DEVIATION REQUEST AND DECISION FORM

PROJECT INFORMATION – NEW LOG ROAD DEVIATION REQUEST

Project Name : Ellicott Town Center Filing No. 1

Planning and Community
Development Department
2880 International Circle
Colorado Springs, Colorado 80910
Phone: 719.520.6300
Fax: 719.520.6695
Website www.elpasoco.com

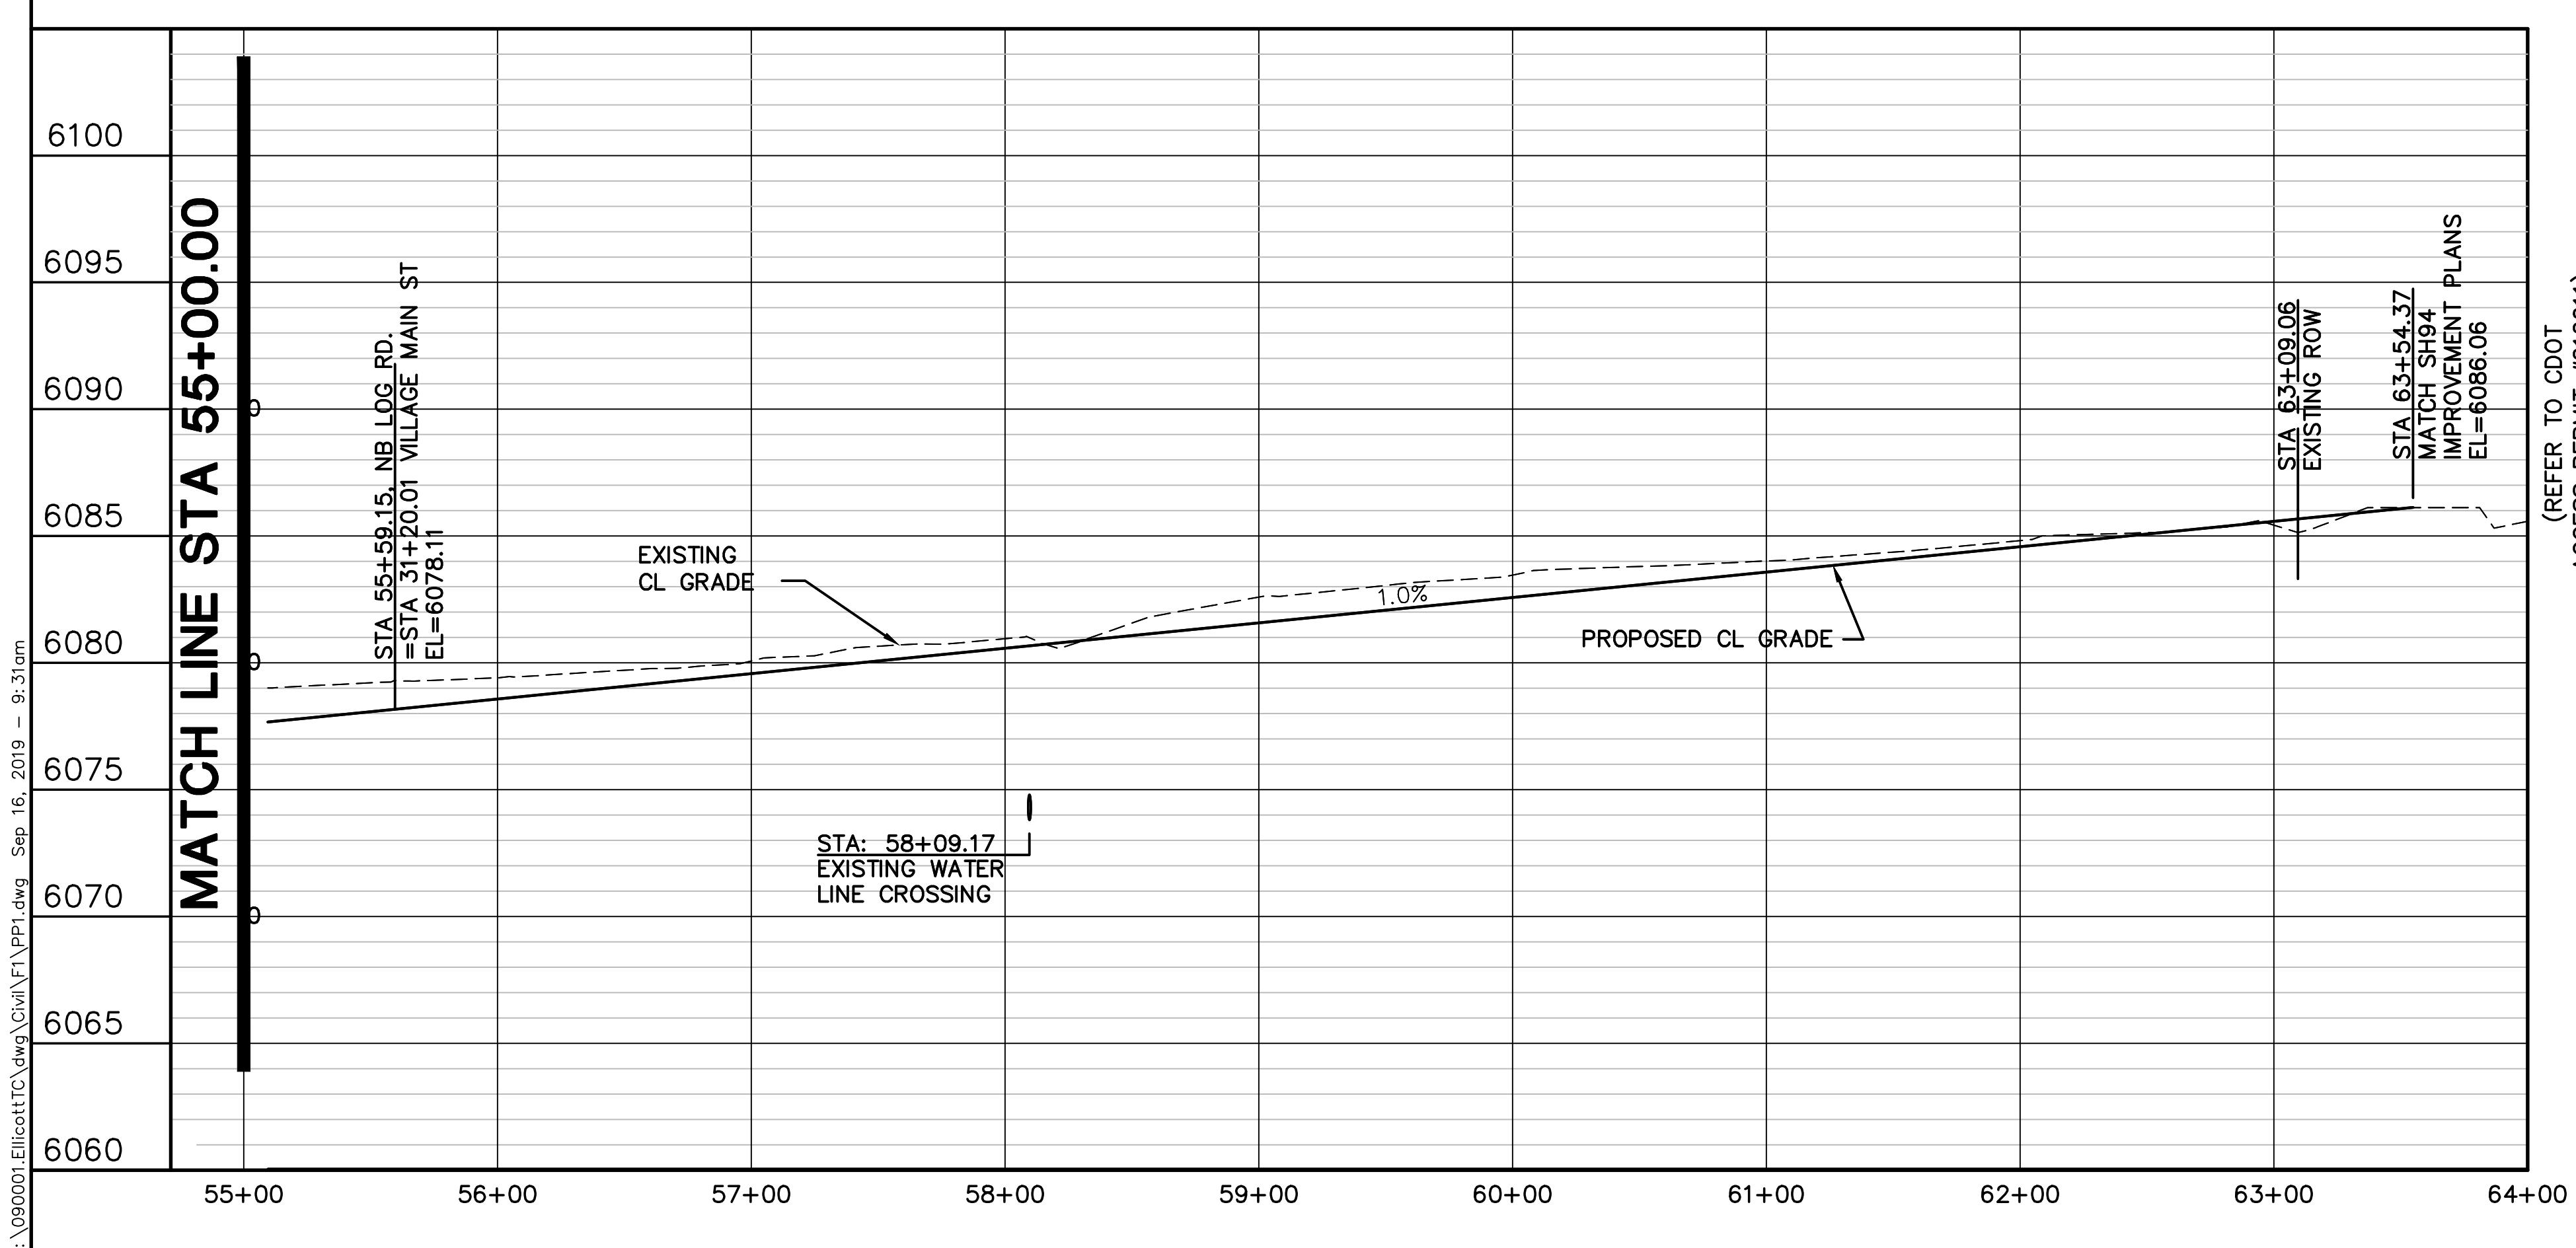
The ECM-prescribed minimum horizontal centerline radius for an urban minor arterial is 565 feet. This deviation request also allows for a slightly reduced minimum centerline radius of 527 feet at couplet transitions as depicted on the attached Plan & Profile Drawing (Sh. PP1).

The proposed minimum centerline radius of 527 feet is only a slight reduction compared to the standard minimum radius of 565 feet.
